## PIC16CR63 Rev. A Silicon Errata Sheet

The PIC16CR63 (Rev. A) parts you have received conform functionally to the Device Data Sheet (DS30234D), except for the anomalies described below.

## Clarifications/Corrections to the Data Sheet:

**FIGURE 1: WRITES TO TIMER1 (EXTERNAL CLOCK / OSCILLATOR MODE)**

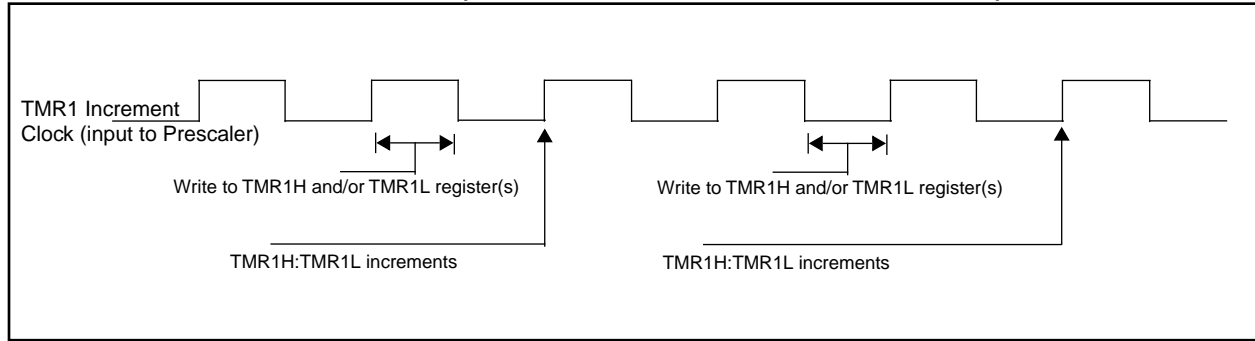
- a) The operation of Timer1 needs some clarification when the timer registers are written when the TMR1ON bit is set.

The internal clock signal that is the input to the TMR1 prescaler affects the incrementing of Timer1 (TMR1H:TMR1L registers and the Timer1 prescaler). When the Timer1 registers are NOT written, the Timer1 will increment on the rising edge of the TMR1 increment clock.

When the TMR1H and/or TMR1L registers are written while this clock is high, TMR1 will increment on the next rising edge of this clock.

When the TMR1H and/or TMR1L registers are written while this clock is low, TMR1 will not increment on the next rising edge of this clock, but must first have a falling clock and then the rising clock for TMR1 to increment.

Figure 1 shows the two cases of writes to the TMR1H and/or TMR1L registers. Due to the V<sub>IH</sub> and V<sub>IL</sub> thresholds on the oscillator/clock pins, external Timer1 oscillator components, and external clock frequency, the Timer1 increment clock may not be of a 50% duty cycle.

The TMR1 increment clock is out of phase of the T1OSO/T1CKI pin by a small propagation delay.
